TOWN AND COUNTRY PLANNING ACT 1990 - CONSULTATION RETURN DC/19/0834/RM

Haverhill: strategic allocation to the north-east, Great Wilsey Park – reserved matters application

Submission of details for the reserved matters access, landscaping, layout and scale for the spine road and associated strategic infrastructure to support the delivery of the first phase of development at Great Wilsey Park.

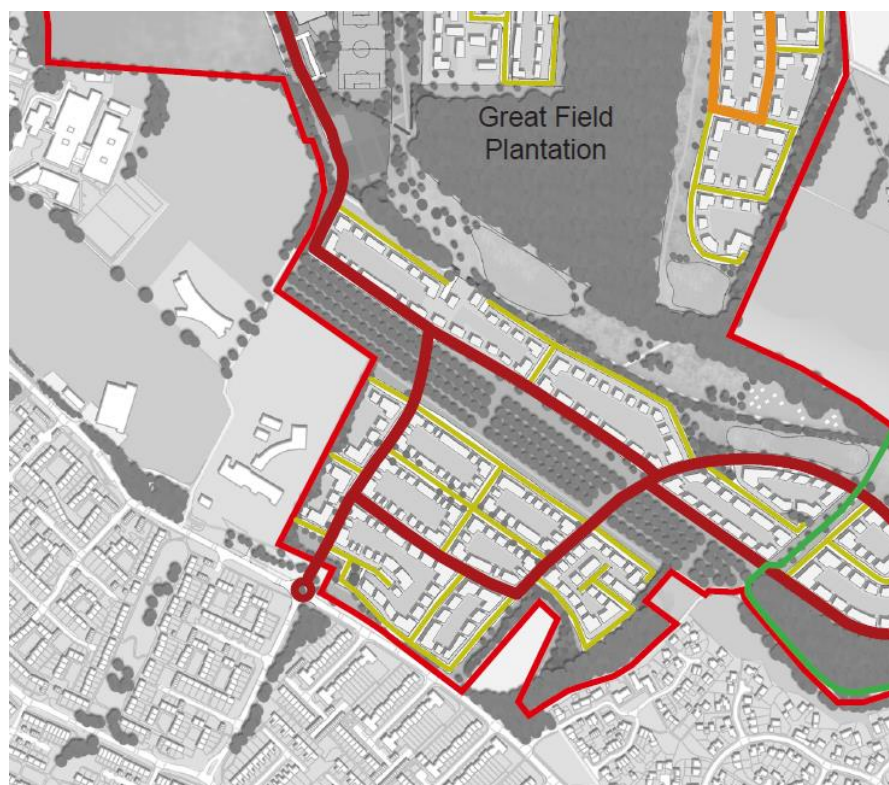
On the Strategic Road network drawing, PB8301-RHD-DE-H1-DR-D-0150 revision I04, the northern road through Parcel A2 (road sections reference B1 and B2) are shown as secondary route, at 5.5m wide. This is contrary to the FPRC Access Parameter Plan (Ref: 5055-ES-04 Rev. F) which indicated that this loop would all be primary street, at up to 7.3 metres wide. See below extract:

The Outline was agreed on the basis that the parcels would have access to a good quality permeable internal layout to give residents multiple routes to join the spine road and travel onto the existing strategic road network in Haverhill. Downgrading the access road through Parcel A2 will reduce the permeability through the site, and lead to traffic being focused on a limited number of streets and on a small number of key junctions. The impact of these changes in movement through the development will need to be clearly evidenced and agreed with SCC and West Suffolk Council.
